Form C-103
 Revised August 1, 2011

SUNDRY NOTICES AND REPORTS ON WELLS
 (DO NOT USE THIS FORM FOR PROPOSALS TO DRILL OR TO DEEPEN OR PLUG BACK TO A DIFFERENT RESERVOIR. USE "APPLICATION FOR PERMIT" (FORM C-101) FOR SUCH PROPOSALS.)

Colorado 6 Fee #2

CONDITIONS OF APPROVAL FOR PLUGGING & ABANDONMENT

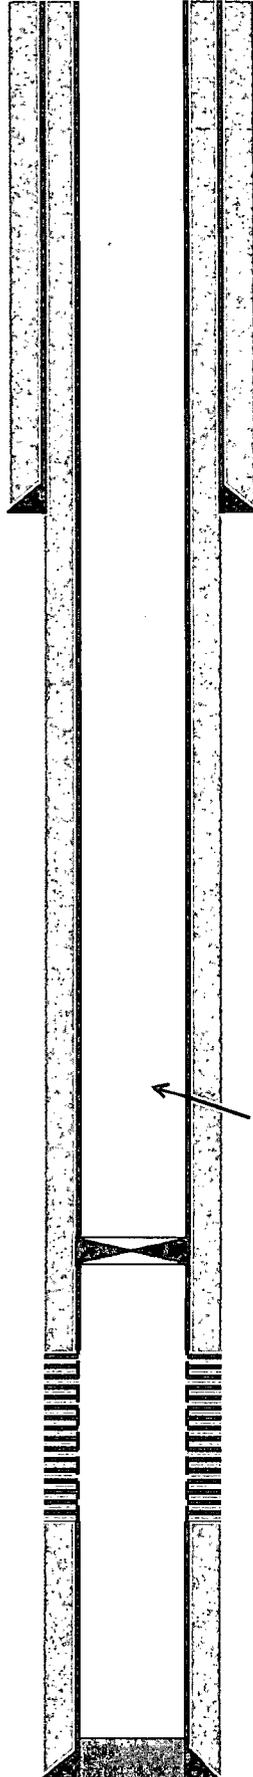
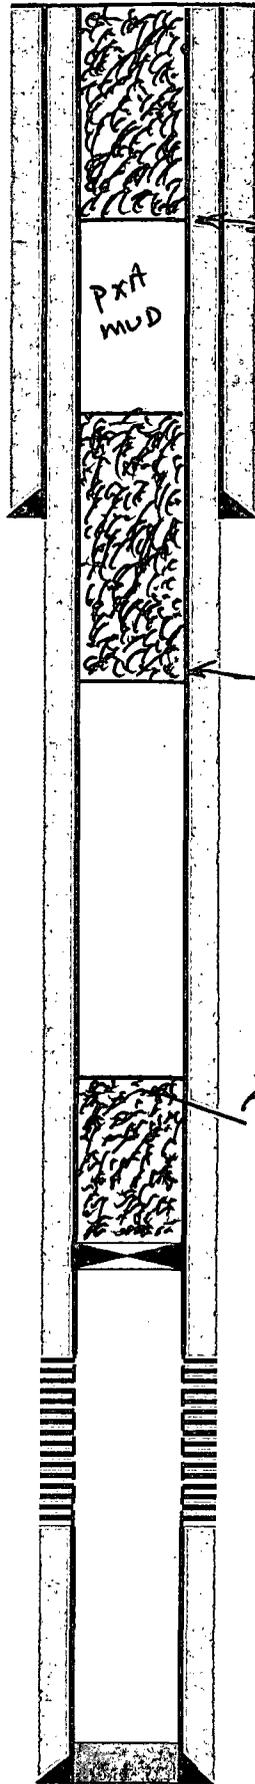
- 1) TAG EXISTING 5-1/2" CIBP @ +/-2,550'; PUMP 30 SXS. CMT. @ 2,550'-2,385' (T/GLOR.); CIRC. WELL W/ PXA MUD.
- 2) PUMP 30 SXS. CMT. @ 1,021'-860' (8-5/8" CSG.SHOE, T/S.A.); WOC X TAG CMT. PLUG.
- 3) MIX X CIRC. TO SURF. 25 SXS. CMT. @ 200'-3'.
- 4) DIG OUT X CUT OFF WELLHEAD 3' B.G.L.; WELD ON STEEL PLATE TO CSGS. X INSTALL DRY HOLE MARKER.

1. Produced water **will not** be used during any part of the plugging & abandonment operation.
2. Notify NMOCD Dist. 2 office at least 24 hrs before beginning work.

7. Every attempt must be made to clean the well bore out to below the perms, before any plugs can be set, by whatever means possible.
8. Cement Retainers may not be used.

9. Squeeze pressures are not to exceed 500 PSI, unless approval is given by NMOCD.
10. Plugs may be combined after consulting with and getting approval from NMOCD.
11. Minimum WOC time for tag plugs will be 4 Hrs.
